DESIGN PUBLIC INFORMATION MEETING

Beacon Street Project
Project File No. 607209
Project Management Section

IN THE CITY OF SOMERVILLE, MASSACHUSETTS

COMMONWEALTH OF MASSACHUSETTS
MASSACHUSETTS DEPARTMENT OF TRANSPORTATION
HIGHWAY DIVISION

Diagram 1

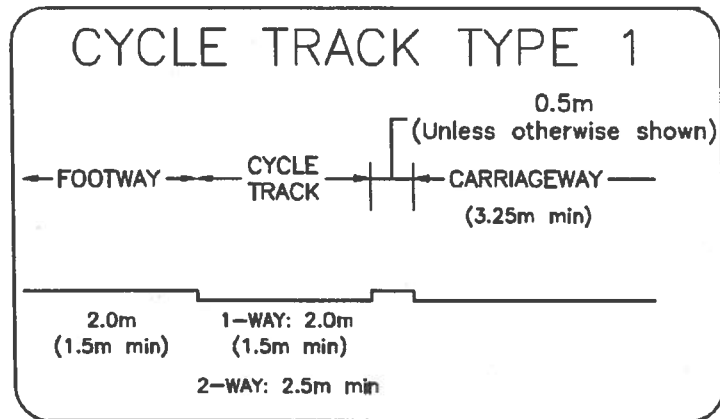
-Drop the cycletrack to roadway height with a curb separating the parked cars from the cycletrack (Diagram 1, Photos 1&2) or drop the cycletrack to a height between the roadway surface and the sidewalk surface with a sloped curb similar to the east side of Beacon Street (Diagram 2). I'll add that Photo 1 is from Montreal, Quebec so the argument that it would be too difficult to clear snow doesn't hold up too well.

Diagram 3 (Red arrow shows example area where ramp could be more gradual in transition between heights.)

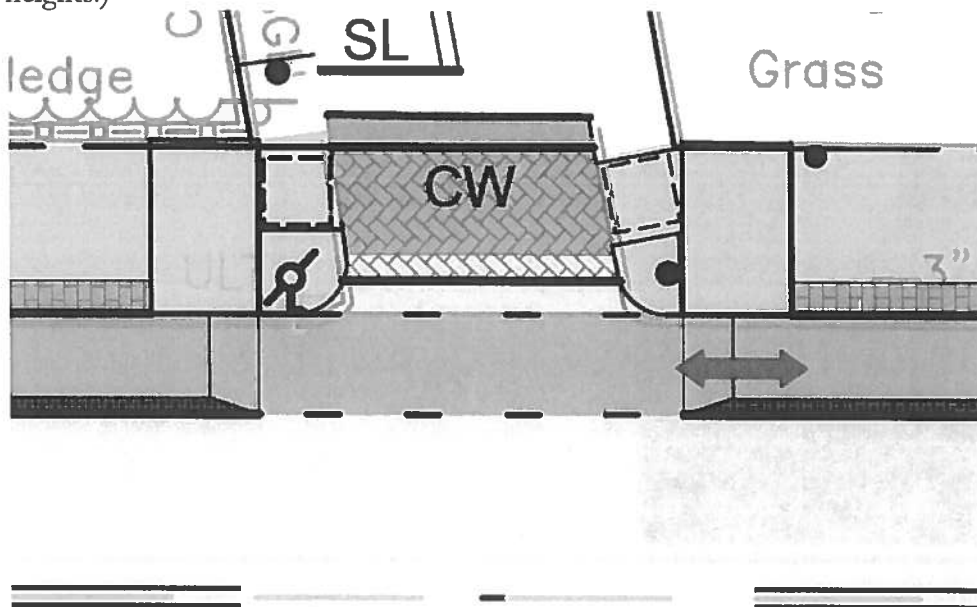
-Raise the crosswalks at side roads to cycletrack height or drop the cycletrack to roadway height. The majority of the roadways on the eastern side of Beacon Street and dead-end streets due to the railroad right of way, therefore the limited traffic they receive shouldn't be given priority via the roadway grade over the cycletrack. In the instance where a ramp in the cycletrack is necessary increase the distance over which that the height changes (Diagram 3).

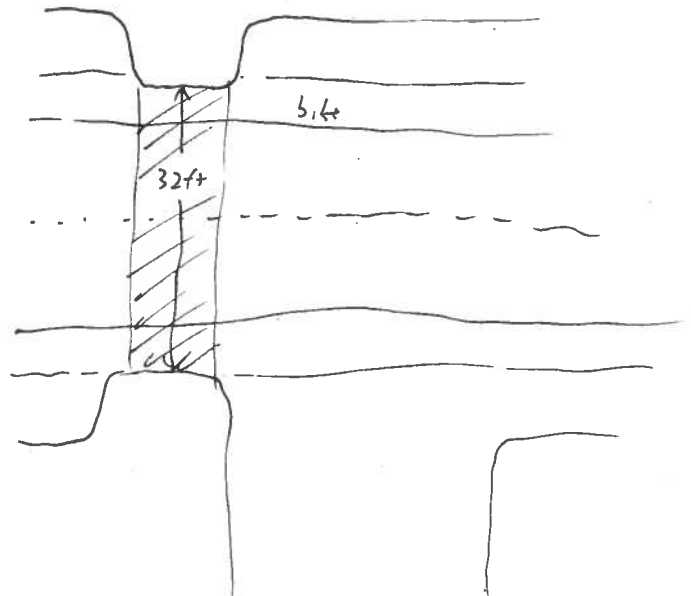
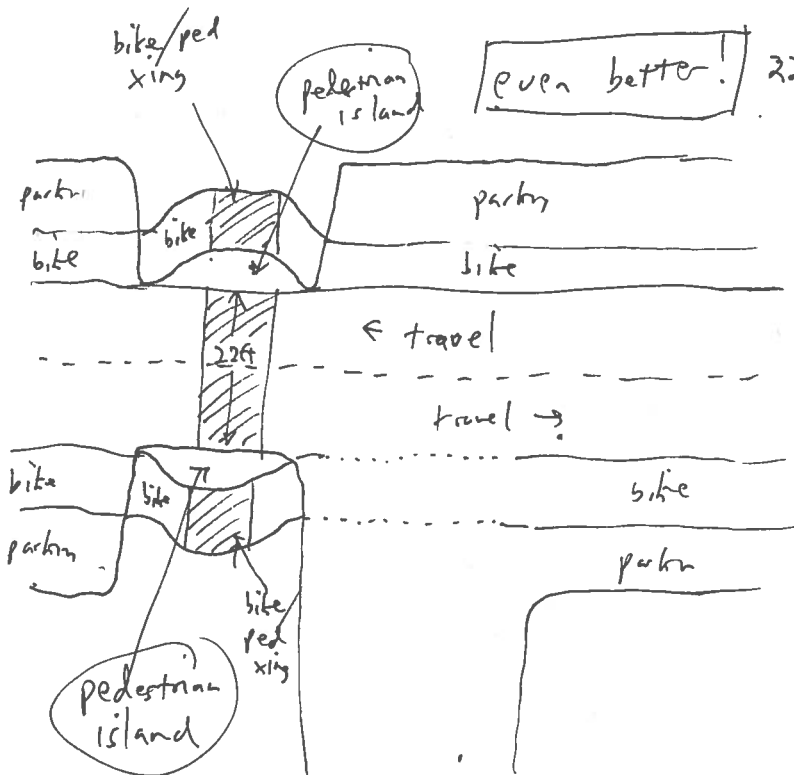
currently
proposed: 46ft

my suggestion 32ft

even better! 22ft!
